LOST CREEK ISR, LLC

**Re: Reply to NRC's May 21, 2015 Letter Regarding License Condition 12.10
Lost Creek ISR Project License SUA-1598, Docket 040-09068, TAC J00717**

Figure 1
Lost Creek Plant Monitoring
for Compliance with 10CFR 40.65

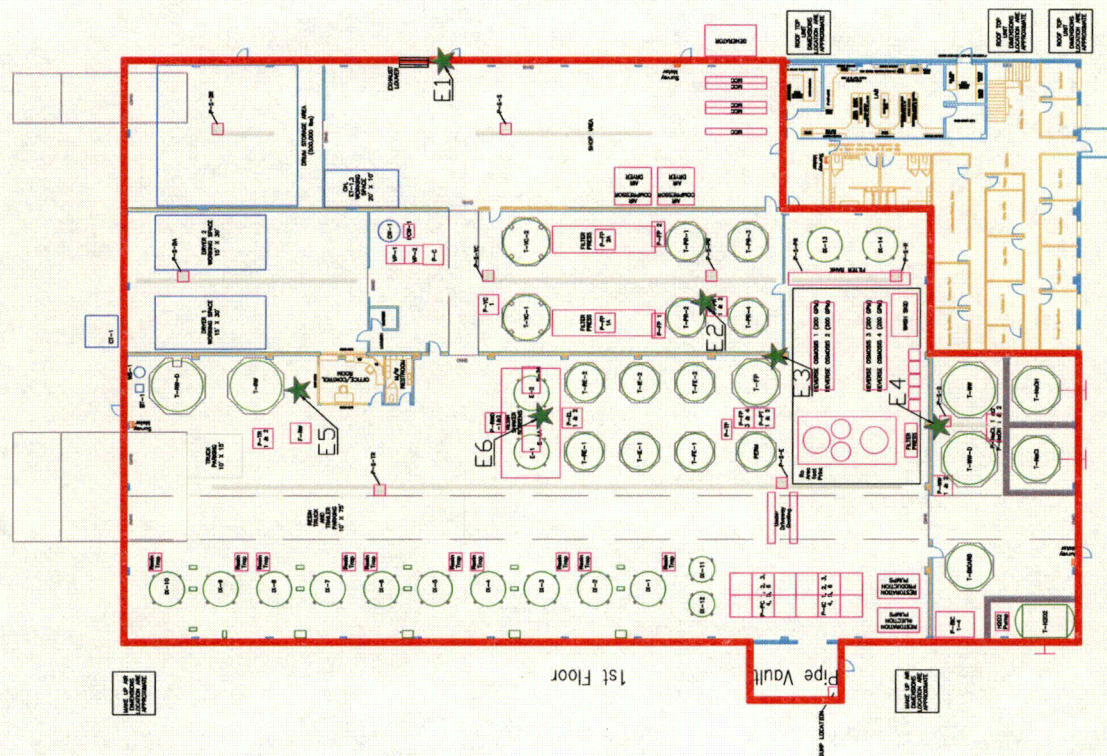
Question 4: Explain the significance of five boxed notes on Figure 1 which describe: (1) outside plant west wall at two location "Make Up Air Dimensions Locations Are Approximate," and (2) outside plant east wall at three locations. "Roof Top Unit Dimensions Locations Are Approximate."

Response 4: The 2 boxes labeled "Make Up Air Dimensions Locations Are Approximate" are the approximate locations of the fans supplying fresh air to the plant. The 3 boxes labeled "Roof Top Unit Dimensions Locations Are Approximate" represent the ventilation units for the offices.
